<p>CARNEGIE FORUM 305 WEST PINE STREET LODI, CALIFORNIA</p>	<p><b>AGENDA</b> <b>LODI</b> <b>SITE PLAN &amp;</b> <b>ARCHITECTURAL</b> <b>REVIEW COMMITTEE</b></p>	<p>REGULAR SESSION WEDNESDAY, NOVEMBER 9, 2016 @ 5:15 PM</p>
---	--	--

**CITY OF LODI**  
**SITE PLAN AND ARCHITECTURAL REVIEW COMMITTEE**  
**Staff Report**

**APPLICATION NO:** 2016-31 SP

**REQUEST:** Request of Site Plan and Architecture Review Committee (SPARC) to consider Site Plan and Architectural Review for a new commercial building at 527 East Lodi Ave. (Applicant: Francisco Sanchez; File Number: 2016-31 SP; CEQA Determination: Exempt Per Section 15332)

## EXTERIOR ELEVATIONS

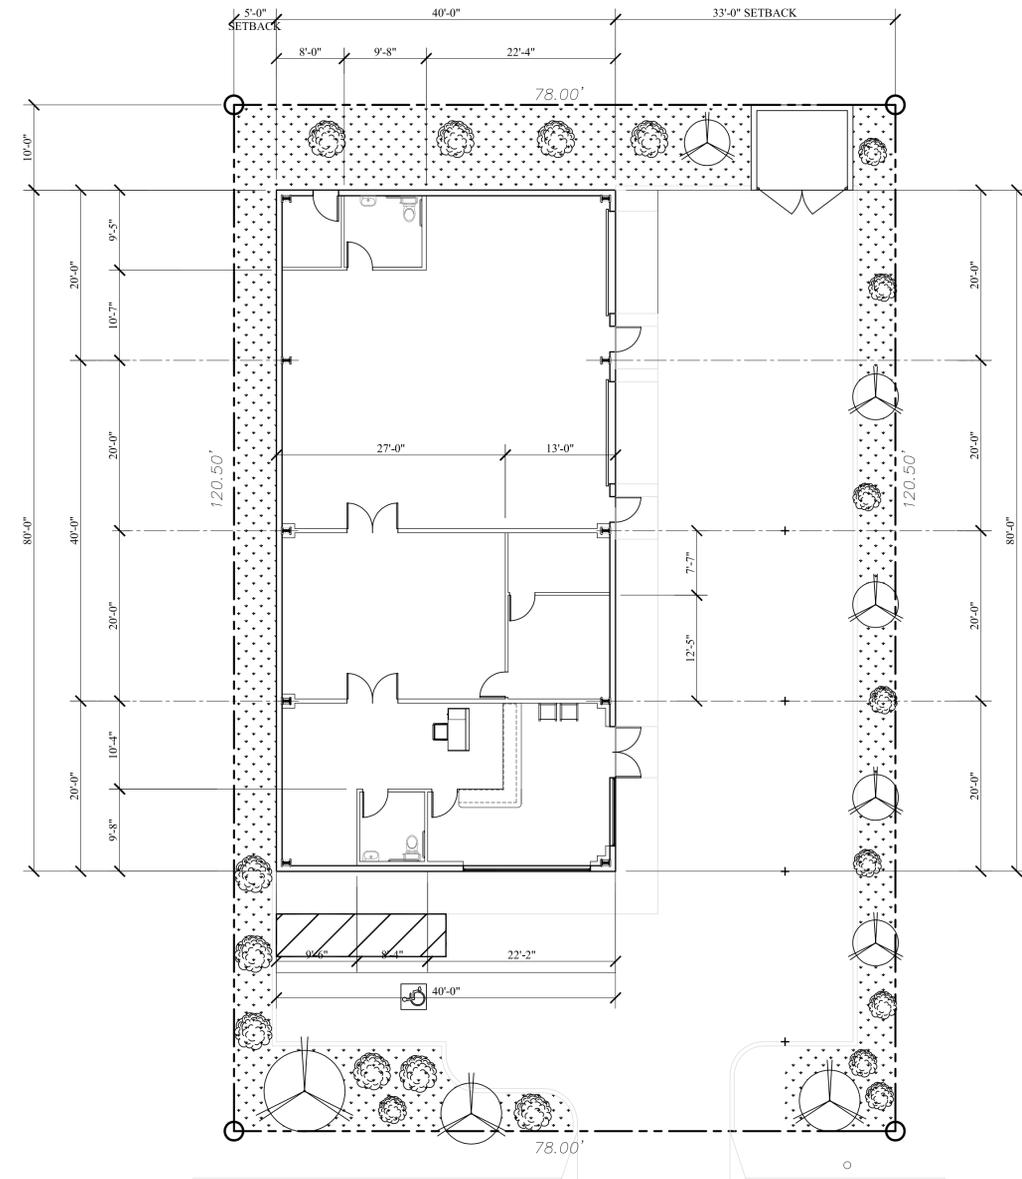
- Metal buildings are not typically allowed within the commercial zoning areas and there are no metal buildings in this area. Staff has conditioned the project to provide stucco or ship lap siding around the entire building with brick or stone accents near the doorway and windows for consistency with the surrounding area architecture. The square and boxy look of the building is consistent with architecture in the area.
- The applicant has provided 1 handicapped parking space and a few parallel parking spaces along the eastern edge of the property. The proposed amount of parking will place a limit on future uses of the property and does not meet parking standards. Staff does recommend a few more conventional parking stalls near the handicap stall.

8. No flashing, moving, animated, temporary signs or banners shall be permitted.
9. The project plans will be modified to include stucco or ship lap wood siding with brick or stone accents near the doorway and windows for consistency with the surrounding area architecture.
